## INSTRUCTIONS TO PERFORM RECALL CAMPAIGN 148

Certain 2018 Eras and 2018 Revels. Eras were manufactured between September 12, 2017 and February 21, 2018. Revels were manufactured between August 29, 2017 and February 20, 2018.

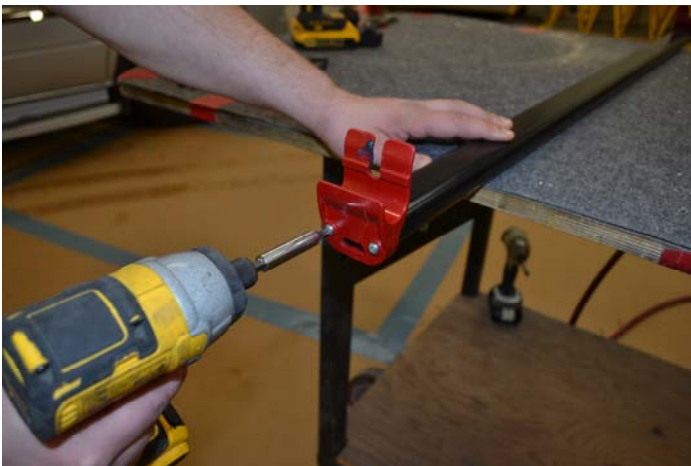
4. "Old" vs. "New" red plastic saddles on roof rails.

5. Install new metal support bracket by using a bolt to locate and position the support bracket. Once bolted into position, use a 3/16" drill bit to drill holes into the adjustable roof rail.

6. Attach the support bracket to the roof rail with two rivets.
